UNITED STATES PATENT AND TRADEMARK OFFICE

APPLICATION NO.	FILING DATE	FIRST NAMED INVENTOR	ATTORNEY DOCKET NO.	CONFIRMATION NO.
10/825,817	04/16/2004	Robert W. Roldan	2003P14527US	8690

Office Action Summary

DETAILED ACTION

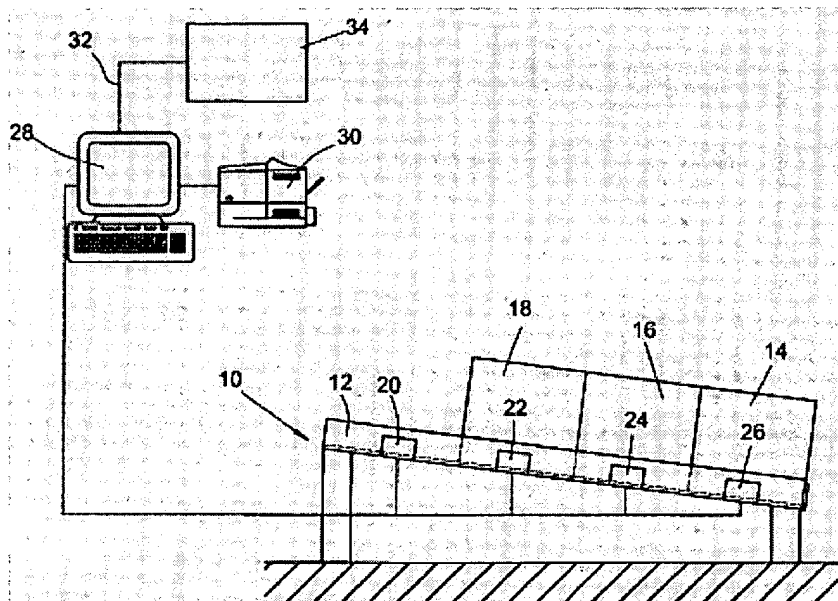
10. Claims 1, 2, 3, and 10 are rejected under 35 U.S.C. 102(b) as being anticipated by D.E. Pat. No. 10041398 to Wilbert.

- (a) positioning manufacturing pieces on a gravity feed rack (components in bin elements 18, 16, 14);
- (b) sensing a removal of the manufacturing pieces (elements 20, 24, 26); and
- (c) electronically notifying in response to (b) (Abstract).

Referring to claim 2, Wilbert teaches the method and system of Claim 1 wherein (a) comprises positioning a plurality of kanbans (elements 18, 16, 14) each having a plurality of manufacturing pieces and wherein (b) comprises sensing removal of a kanban (Abstract).

Referring to claim 3, Wilbert teaches the method of Claim 1 wherein (b) comprises sensing when a position along the gravity feed rack is free of manufacturing pieces (Abstract and element 20).

gravity feed rack (See figure above) and wherein (b) comprises sensing at a position higher than the lower position on the gravity feed rack (See figure above, for example, sensor 24 is at a higher position than sensor 26).

Referring to claims 13, Wilbert teaches a system of Claim 11, wherein the sensor is positioned to sense at a location along the gravity feed rack such that the lack of the manufacturing piece is sensed while another manufacturing piece is present below the location (See the figure).

Referring to claims 11, 17, and 20, Wilbert shows a gravity feed rack with sensors adjacent thereto (see the figure above). Wilbert clearly teaches the computer 28 generates a replenishment notification signal in response to a sensor detecting a drop in the number of supply
